DA 10.2009.231 - 25 Etonville Parade

**RE: Development Application 25 Etonville Parade and 1-3 Mackay Street, Ashfield
SEPP 65 COMMENTS AND RECOMMENDATIONS**

I refer to your letter dated 18th January 2010 and accompanying documentation for DA 10.2009.231.1 at 25 Eton Parade, Ashfield. The proposed development is for an aged care complex and includes proposed primary access via a new bridge across the adjacent Sydney Water channel. An older existing bridge would be demolished and removed.

Accessibility Review of Development Application

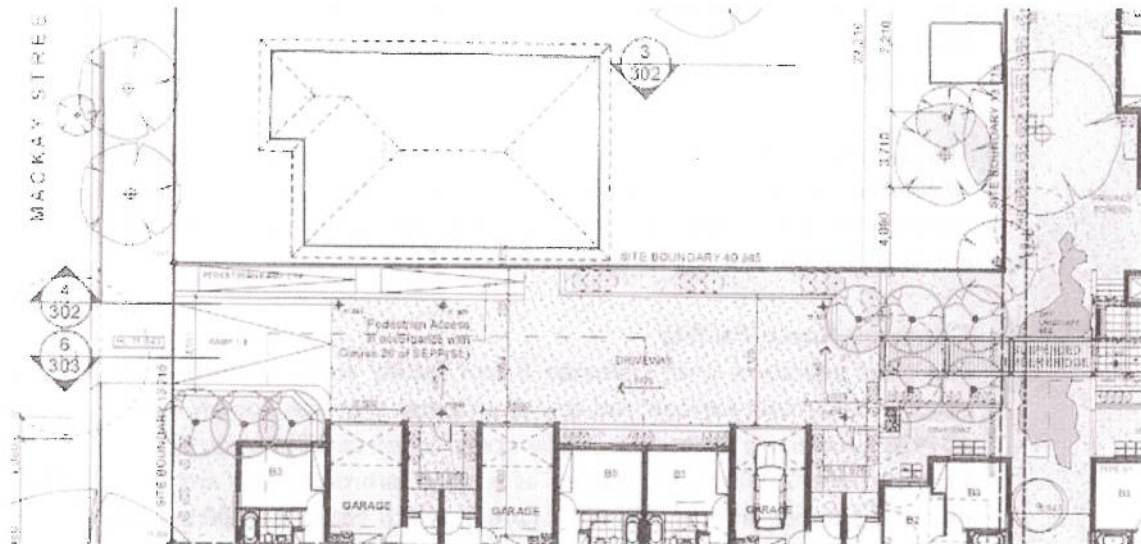
- Schedule 3, **Site Access – Wheelchair Access**
 Clause 2(1)(2) The plans show two site entry points from;
- Mackay Street
 - Etonville Parade

Mackay Street – The plans show a 1:14 pedestrian access ramp from the Mackay Street footpath into the site and to a pedestrian bridge and the central podium area of the development in a manner that can comply with ASI428.1 and the SEPP; HS, subject to further detailing of the ramp, ridge and pathway surfaces at construction certificate stage.

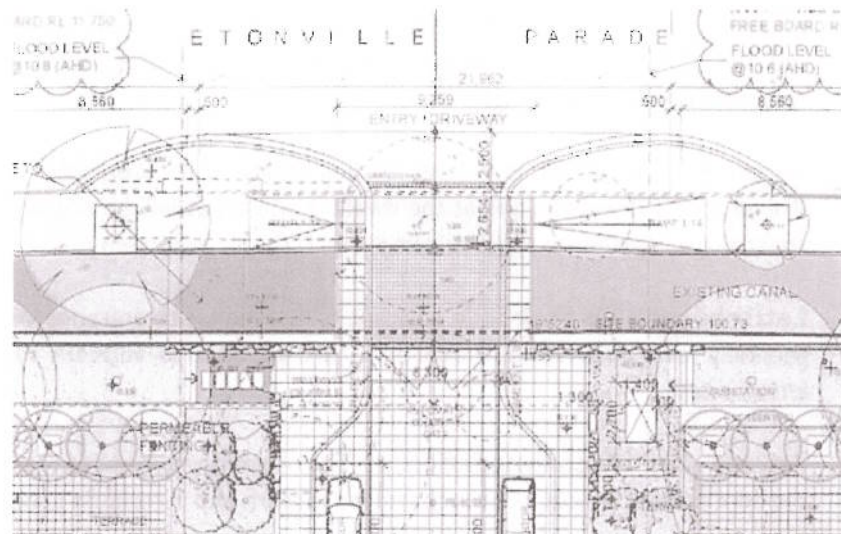
- Schedule 3, **Etonville Parade** - The plans show that the development will provide a new driveway bridge entry from Etonville Parade with a 2500mm length driveway with a 1:14 gradient adjoining ramps consistent with ASI428.1.

Clause	Item Assessment	Complies
	The 1:14 gradient ramps can comply with AS1428.1 if handrails are installed. However, the adjacent footpaths are inaccessible due to trees, power poles and broken pavement and there are no kerb ramps to cross the road.	NO
	The pedestrian gates on each of the side of the driveway entry do not provide the circulation space to comply with AS1428.1.	NO
	Therefore the entrance is effectively inaccessible and fails to satisfy clauses 38 and Schedule 3 clause 2 of the SEPP HS.	NO
Schedule 3, Clause 2(1)(2)	Intrasite Pathways - Within the site the plans indicate on-grade pathways and ramps to facilitate wheelchair accessible paths of travel to all building entrances, villas and communal facilities in a manner that will comply with AS1428.1 and thereby satisfy schedule 3 clause 2(1) of the Housing for Seniors Policy, subject to further detailing of ramps, doors and landings at construction certificate stage.	YES
